Planning Report

Ridgeview Subdivision, Lot 7 – Artrip Residence – Final Plat

Agenda Item	3
Case Number	15-082FP
Location	207 Marion Street South side of Marion Street 110 feet east of Monsarrat Drive.
Proposal	To revise a previously approved Final Plat for one lot to adjust a front building line requirement from 75 feet to 35 feet.
Property Owners	Brenda and Terry Artrip
Planning Contact	Tammy Noble, Senior Planner (614) 410-4649, tnoble@dublin.oh.us
Request	Review and recommendation of approval to City Council for a Final Plat under the provisions of the Subdivision Regulations.
Planning Recommendation	Recommendation of approval with one condition: Based on Planning's analysis, the proposal meets the requirements of the Subdivision Regulations, subject to the following condition. 1) That the applicant ensures that any minor technical adjustments to the plat are made prior to City Council submittal to the satisfaction of the City Engineer.

15-082PP/FP
Preliminary Plat/Final Plat
Artrip Residence
207 Marion Street

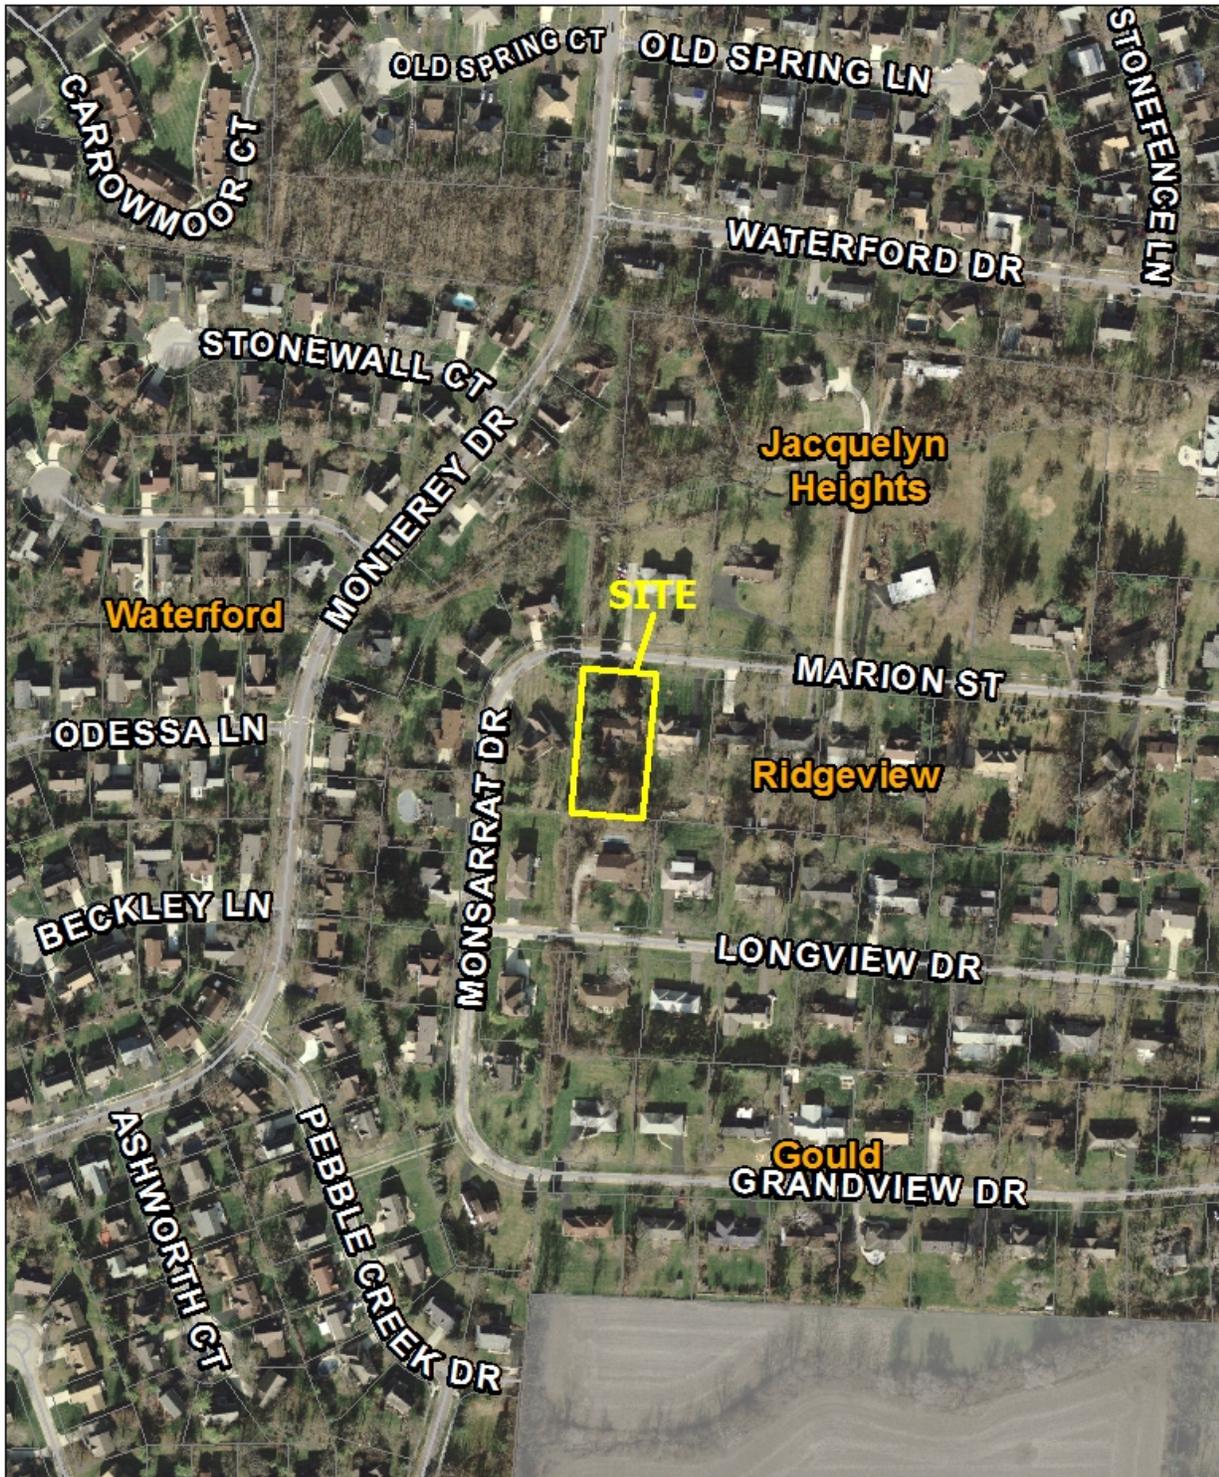
Analysis	Final Plat
Process	Following a recommendation by the Commission, the final plat will be forwarded to City Council for final action. The final plat can be recorded after City Council approval.
1) Plat Information and Construction Requirements <i>Conditions 1</i>	Criterion met with a condition: This proposal is generally consistent with the requirements of the Subdivision Regulations. The applicant must ensure that any minor technical adjustments to the plat are made prior to final City Council submittal.
2) Street, Sidewalk, and Bike path Standards	Criterion met: No requirement for additional infrastructure are required.
3) Utilities	Criterion met: The proposal does not impact, nor require, utility service.
4) Open Space Requirements	Criterion met: There are no open space requirements for this plat.

Recommendation	Final Plat
Approval	This proposal complies with the final plat criteria and a recommendation to City Council for approval of this request is recommended with a condition.
Condition	1) That the applicant ensures that any minor technical adjustments to the final plat are made prior to City Council submittal to the satisfaction of the City Engineer.
